4 - STROKE  
VS/VX/VZ/VL BULLETIN NO. 24  
DATE: 7/26/2004

## 1999 - 2004 VZ800X-K4 E33 (California models only) MARAUDER FUEL SYSTEM EVAPORATIVE CANISTER REPLACEMENT

**Suzuki Motor Corporation has decided that a defect which relates to motor vehicle safety exists in certain 1999 - 2004 model year VZ800X-K4 E33 (California models only) Marauder motorcycles. Suzuki Motor Corporation is conducting a voluntary Safety Recall Campaign.**

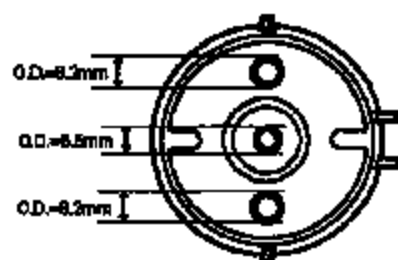
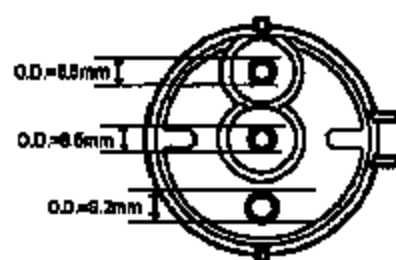
**Note:** The original canister and new canister have different locations/sizes of pipes.

- 10.** Fit the new canister (Item A). Connect the purge hose ⑪, the surge hose ⑫ and the clips onto the new canister as illustrated.

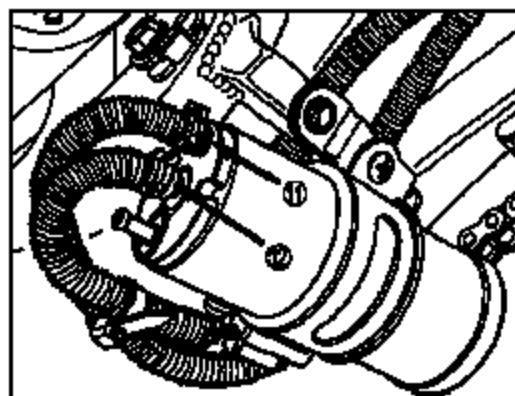
**Note:** Use the new clip (Item I, 11.6mm) on the purge hose ⑪ and (Item J, 11mm) on the surge hose ⑫.

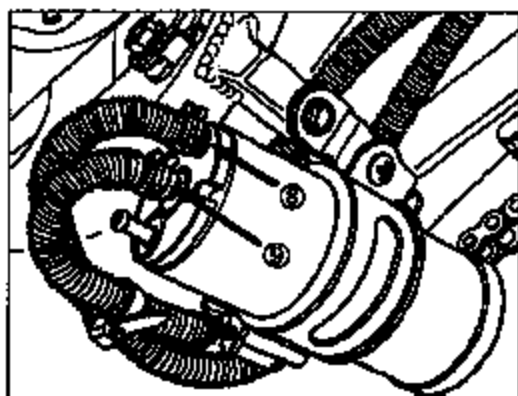
10. Fit the new canister (Item A). Connect the purge hose ⑧, the surge hose ⑨ and the clips onto the new canister as illustrated.

Note: Use the new clip (Item I, I.D. 11.6mm) on the purge hose ⑧ and (Item J, 11mm) on the surge hose ⑨.

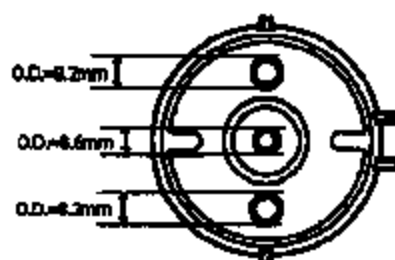
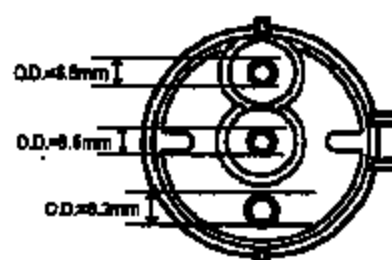
Note: The original canister and new canister have different locations/sizes of pipes.
